TRANS/WP.29/GRRF/2002/17/Rev.4
8 July 2005

REVISED PROPOSAL FOR DRAFT AMENDMENT TO REGULATION No. 64

(Temporary use spare wheels/tyres)

Revision 4

Paragraph 5.1.4.1., amend to read (the diagram is not amended):

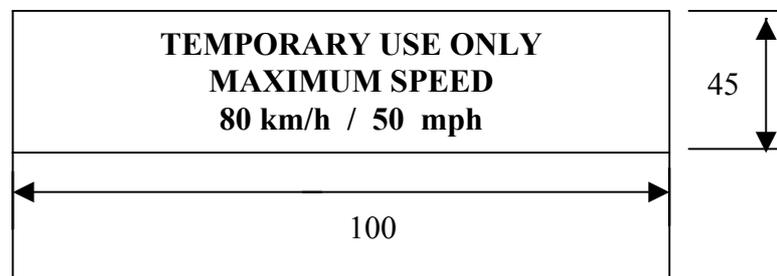
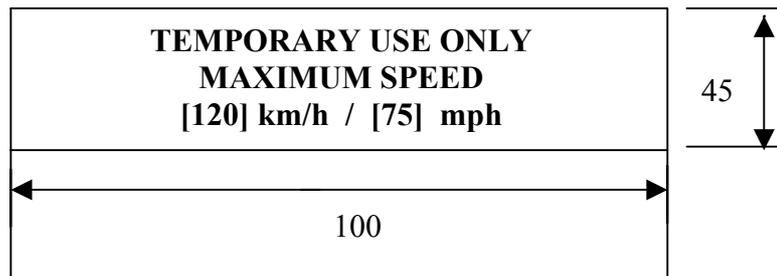
"5.1.4.1. An 80 km/h maximum speed warning symbol arranged in accordance with the diagram below shall be permanently displayed on the outer face of the wheel in a prominent position.

In the case of vehicles intended to be sold in countries using imperial units of measurement, an additional warning symbol, identical to that described above, with the exception that the figure "80" shall be replaced by "50" and the wording "km/h" by "mph", shall be permanently displayed on the outer face of the wheel in a prominent position.

Alternatively a single warning symbol arranged in accordance with the diagram below, shall be permanently displayed on the outer face of the wheel in a prominent position.

Upper case letters shall be at least 5 mm high and the numbers "80" and "50" shall be at least 20 mm high with the elements that make up each character of the number at least 3 mm line thickness. Lower case text shall at least have a line height of 5 mm. All text shall be enclosed in a border and be on a background of contrasting colour.

The requirements of this paragraph shall only apply to types 1, 2 and 3 temporary use spare unit as defined in paragraphs 2.11.1., 2.11.2. and 2.11.3."
